FINDINGS/CONCLUSIONS/DECISION
Town Center Phase I: SW Quadrant
Unified Zone Development Plan ("UZDP")
File Number: UZDP2019-00562

DECISION: The UZDP is denied.

Figure 3: The Green Spine as described in the Town Center Infrastructure Plan

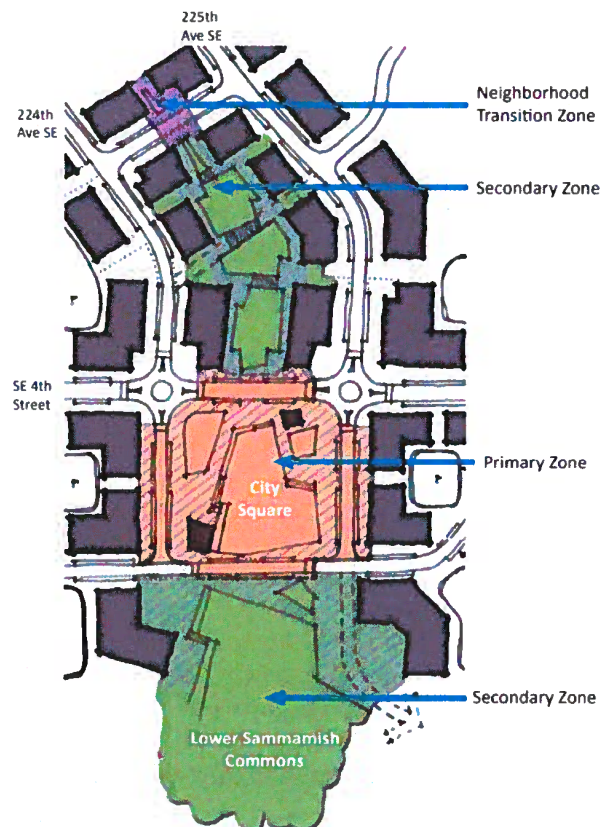
STCA has not demonstrated compliance with SMC 21B.95.050(4)(a)(c)(g) by failing to include the City Square, the primary zone of the Green Spine as part of the UZDP.

STCA originally proposed that the City Square be located on City owned property (i.e. Lower Sammamish Commons Park) (Exhibit 13.j). The City responded, as summarized in the Plan Review Summary dated March 10, 2020, that the area where STCA proposed to locate the City Square is actually identified in the Town Center Infrastructure Plan as the secondary zone of the Green Spine and directed STCA to locate the City Square south of SE 4th Street between Blocks 5

and 6 on the proposed site plan. The City also directed STCA that the design of the City Square must adhere to the primary zone development guidelines described in the Town Center Infrastructure Plan and as required by SMC 21B.95.050(1)(g) (**Exhibit 20.a**).

In response to the City's initial review comments and the June 1, 2020 meeting, STCA submitted an updated site plan on June 22, 2020 proposing that the City Square be located north of SE 4th Street and excluded it altogether from the Phase I development proposal (**Exhibit 35.g**). STCA further described *"that they will work with the City to identify the appropriate area for a City Square north of SE 4th Street. That the City, as contemplated in the Town Center Plan and Infrastructure Plan, contributes to key infrastructure components, including the Green Spine, and that all this could be part of the final site selection process in future phases."*
